VALUE ENGINEERING CHANGE PROPOSAL
MISSOURI DEPARTMENT OF TRANSPORTATION

Contract ID : 080919-401

Job No. J4I1650

1. **Description of existing requirements and proposed change(s). Advantages/Disadvantages**
Retaining Wall A7505 is to be constructed as a cast-in-place concrete retaining wall. Emery Sapp & Sons proposes to construct the retaining wall as an MSE wall in order to decrease construction costs and improve the aesthetics of the project.

CAST-IN-PLACE RETAINING WALL

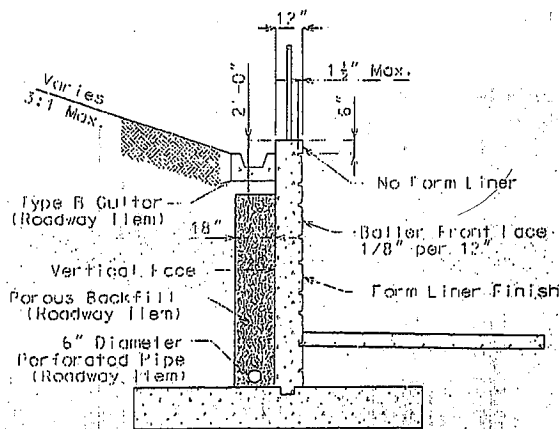
- Reduction in the rock cut required.
- Reduction in right of way, construction easements and permanent easements.
- Ashlar stone form liner can be used.
- Minimizes interference with utilities. There will be an active utility corridor behind wall.

Disadvantages

- Total construction cost is higher.

Total Construction Cost: \$244,652 (\$228,512 in Bridge Items and \$16,140 in Roadway Items)

MECHANICALLY STABILIZED EARTH (MSE) WALLS

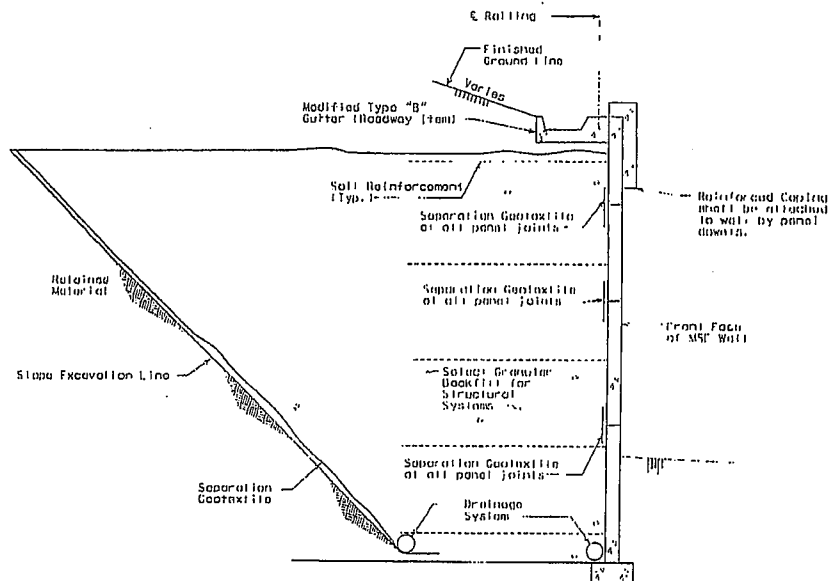
- Ashlar stone form liner can be used.
- Total construction cost is lower.

Disadvantages

- Increases the rock cut required.
- Increases the required amount of right of way, construction easements and permanent easements.
- Increases the likelihood interference with utilities. There will be an active utility corridor behind wall.

Total Construction Cost: \$233,706 (\$146,036 in Bridge Items and \$87,670 in Roadway Items)
